CITY OF NOVI CITY COUNCIL NOVEMBER 23, 2020

SUBJECT: Consideration of approval of Change Order No. 8 to DVM Utilities, Inc. for the Nine Mile Road Sanitary Sewer project (Evergreen Court to Kensington) in the amount of \$481,772, and amend the budget.

WORK CHANGE DIRECTIVE & CHANGE ORDER No. 8

Temporary Diversion Pumping System to Garfield Lake

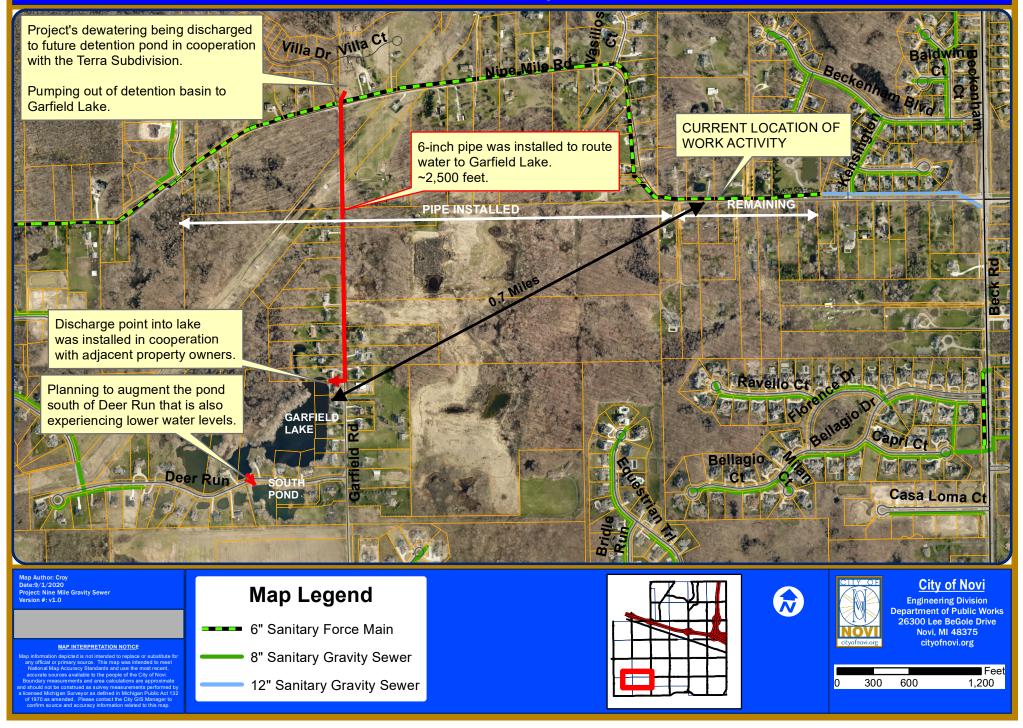
After several residents reported a receding lake level, staff investigated options to return water back into the lake and surrounding wetlands. Since the dewatering for the project was routed towards the new Terra subdivision detention basin, the simplest and most cost effective solution to get water back to Garfield Lake, was to pump from the Terra basin south down Garfield Road. In late June, a temporary 6" pipe line was installed through the ditch line with an outlet in Garfield Lake (see attached map). Staff cooperated with residents to find an appropriate route for the piping along Garfield Road and over to Garfield Lake. One of the residents installed a "gauge" on his dock that has allowed staff to closely monitor the lake levels (see below pictures).

The redirection pumping has been in operation for over two months and instantly made an impact on the water level (raised 2.5 feet). The level has been closely monitored after the initial rise and has fell around 0.5 feet. Over the past month, it has remained relatively constant (2 feet higher). According to an Ecologist on OHM Advisors staff, the lake level is approximately 1.5 feet below the "normal annual low" water level.

Staff will be bringing a change order to the September 14 City Council Meeting to cover the costs for the setup, pumps, and fuel associated with the three months of temporary diversion pumping. To date, the costs are approximately \$70K. Since the water level is fluctuating and the project still has several months of construction remaining, staff recommends continuing the diversion pumping for the duration of the project. Additional costs are ~\$13K/month and can be included in a balancing change order with other items when the project is closer to completion.

Furthermore, staff recommends leaving one or two of the dewatering shafts and the temporary pipe in place after the project is complete. This will provide a security measure to pump more into the impacted lake and surrounding wetlands if necessary.
